<i>Project</i>	IEEE 802.16j Mobile Multihop Relay Task Group	
<i>Title</i>	Enabling MAC tunneling over HARQ in 802.16j	
<i>Date</i>	2007-04-06	
<i>Source(s)</i>	<p><i>Jeffrey Z. Tao, Koon Hoo Teo, Jinyun Zhang</i> Mitsubishi Electric Research Lab 201 Broadway Cambridge, MA 02139 USA</p> <p><i>Toshiyuki Kuze, Shigeru Uchida, Kentarou Sawa</i> Mitsubishi Electric Corp 5-1-1 Ofuna Kamakura, Kanagawa 2478501, Japan</p> <p><i>Jerry Sydir, Kerstin Johnsson, Hyunjeong Lee</i> Intel Corporation 2200 Mission College Blvd., Santa Clara, CA 95054, USA</p> <p><i>Tzu-Ming Lin, Wern-Ho Sheen, Fang-Ching Ren, Jen-Shun Yang, Chie Ming Chou, I-Kang Fu, Ching-Tarnng Hsieh, Jui-Tang Wang</i> Industrial Technology Research Institute (ITRI)/ National Chiao Tung University (NCTU), Taiwan 195,Sec. 4, Chung Hsing Rd. Chutung, Hsinchu, Taiwan 310, R.O.C.</p> <p><i>Yuan-Ying Hsu</i> Telcordia Applied Research Center Taiwan Co., Taipei, Taiwan</p> <p><i>Okuda Masato</i> Fujitsu Laboratories LTD. Kamikodanaka 4-1-1, Nakahara-ku Kawasaki, Japan. 211-8588</p> <p><i>Yuefeng Zhou</i> Fujitsu Laboratories of Europe Ltd Hayes Park Central, Hayes End Road, Hayes, Middlesex, UB4 8FE, UK</p> <p><i>Sungjin Lee, Hyunjeo

Figure 1: Insertion of PDU SN extended subheader.

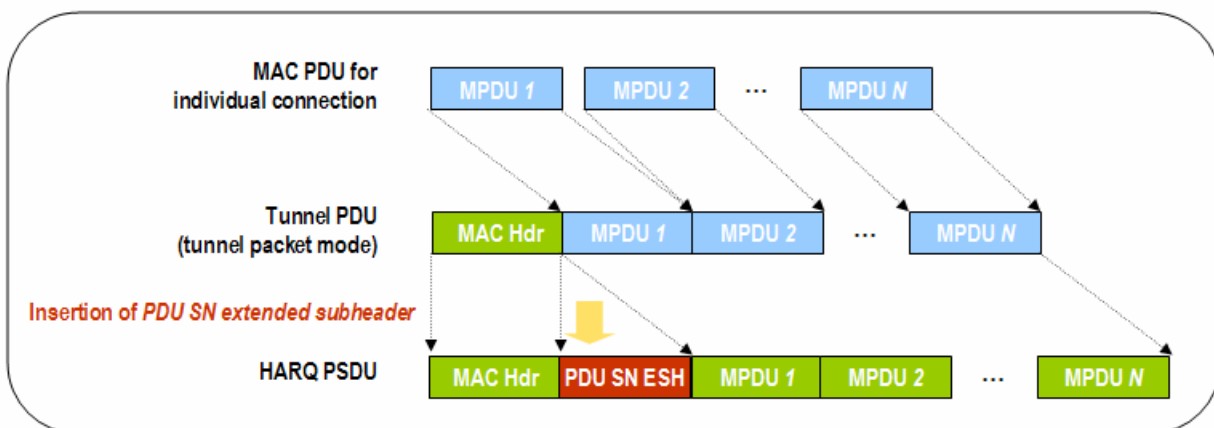
1. **Tunnel identification in HARQ:** When handled by HARQ, a MAC tunnel shall be perceived as one single connection. Thus, it is a natural solution to use the tunnel CID [1] in the RCID field.
2. **Out-of-order data delivery:** To address this problem for tunnel packet mode, a PDU sequence number (SN) extended subheader shall be inserted immediately after the tunnel header, as shown in Figure 1.

If a tunnel PDU constructed in the tunnel packet mode will be processed by parallel HARQ channels, the tunnel PDU then shall contain a PDU SN extended Subheader after the tunnel header.
